**AGENDA ITEM SUMMARY**
**December 10, 2012**

**Subject:** Appeal of Hearings Official Decision: Deerbrook PUD (PDT 12-1)

# DRAFT FINAL ORDER OF THE EUGENE PLANNING COMMISSION ON APPEAL OF DEERBROOK PUD (PDT 12-1)

# L2.0

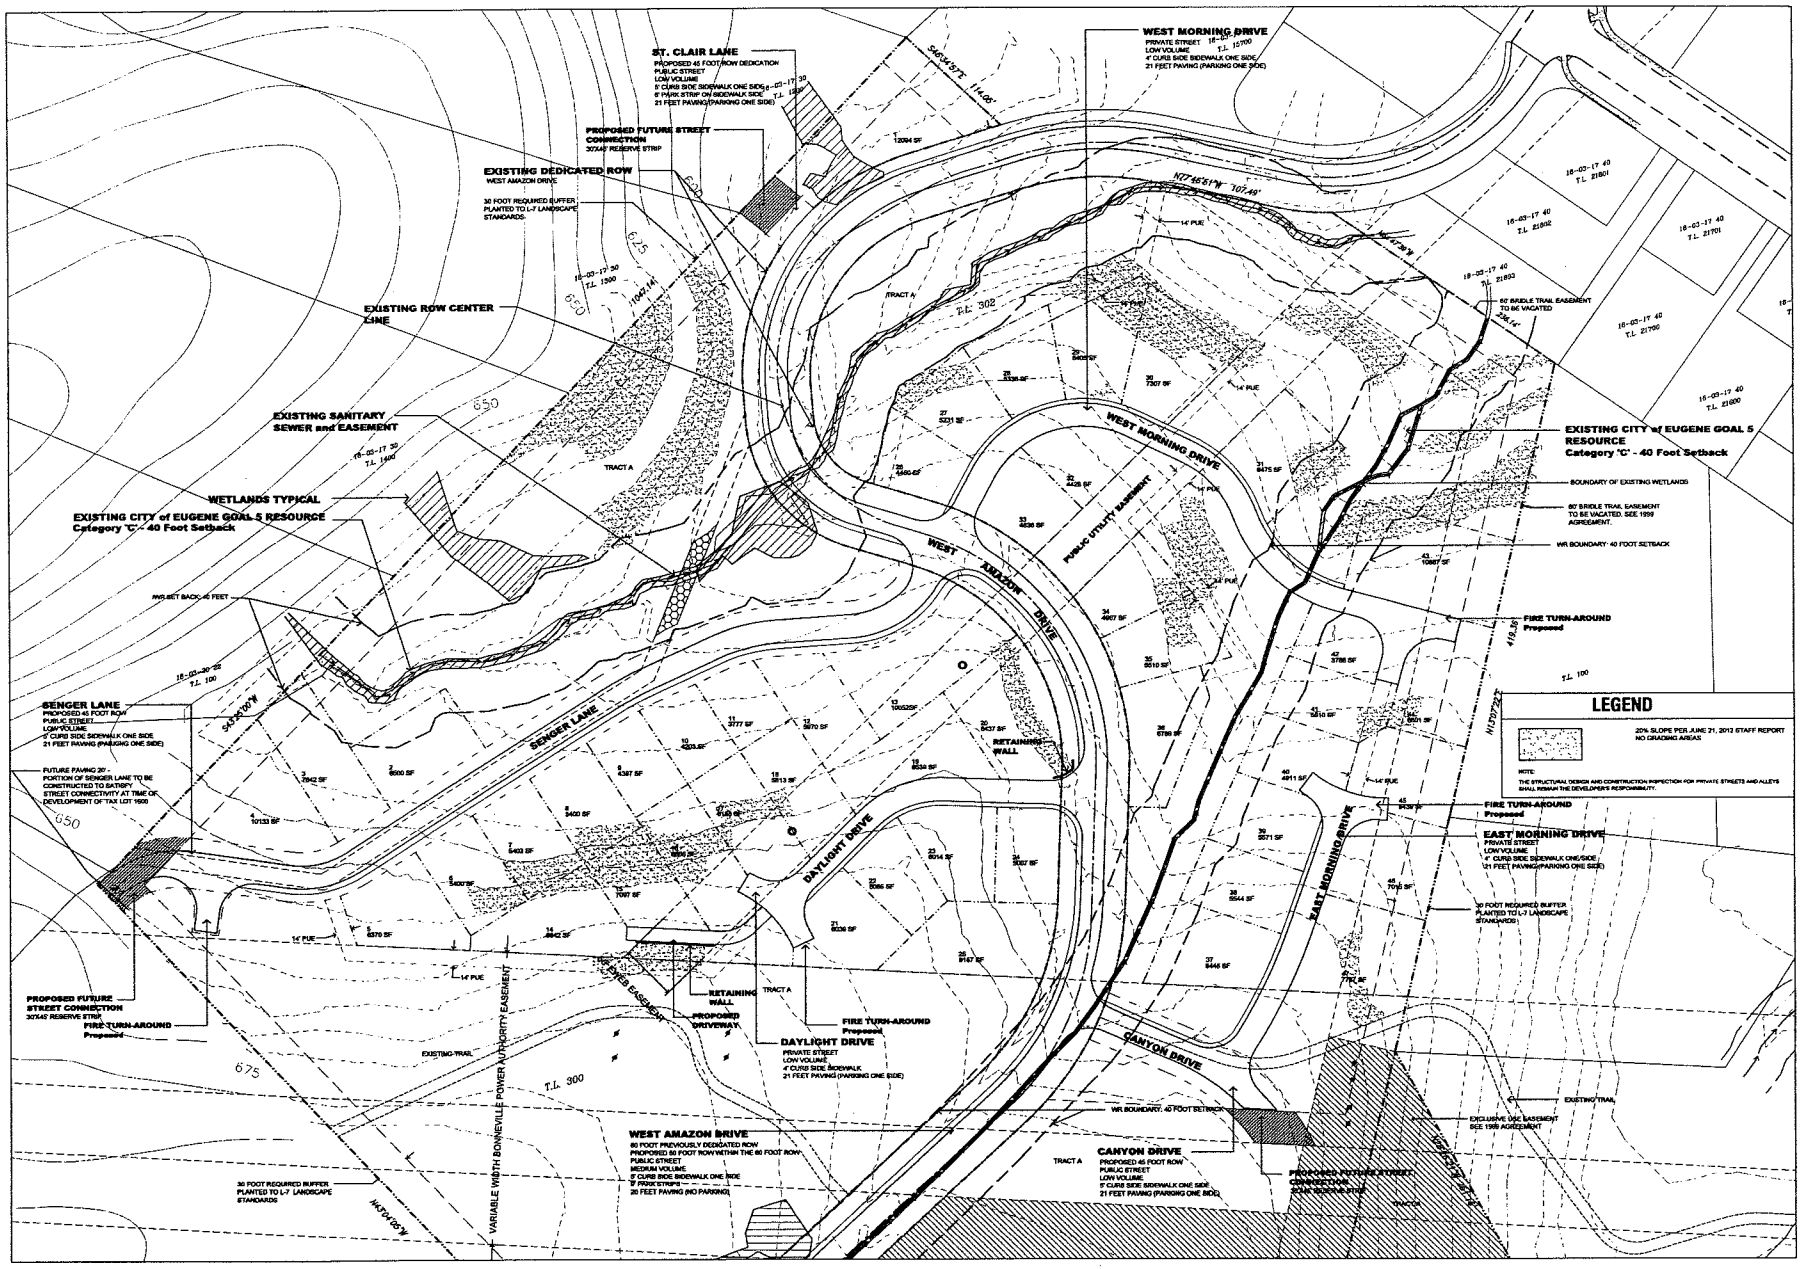
- The final PUD plans shall be revised to show the areas of 20% slope and removal of proposed development from the eastern portion of the site, consistent with the Applicant's illustrative 47-lot plan (Sheet L2.0 of the dated August 22, 2012). The following restriction shall also be noted: "The shaded areas of 20 percent slopes shall not be graded, pursuant to EC 9.8325(5). Construction site management shall include protective fencing of these areas. Utilities in these locations will need to be installed without grading, such as with boring or other construction technique."

PC Decision: The PC accepts these arguments and determines that the HO erred in relying on the Matthews Map. The PC reverses the HO's decision by confirming that Sheet L2.0 of the Applicant's plan dated August 22, 2012 (see attached) is the correct map for determining compliance with the approval criterion at EC 9.8325(5). Approval condition #3, which is listed at the end of this Final Order, ensures compliance with this criterion.

3. The final PUD plans shall be revised to show the areas of 20% slope and removal of proposed development from the eastern portion of the site, consistent Applicant's illustrative 47-lot plan (Sheet L2.0 of the dated August 22, 2012). The following restriction shall also be noted: "The shaded areas of 20 percent slopes shall not be graded, pursuant to EC 9.8325(5). Construction site management shall include protective fencing of these areas. Utilities in these locations will need to be installed without grading, such as with boring or other construction technique."
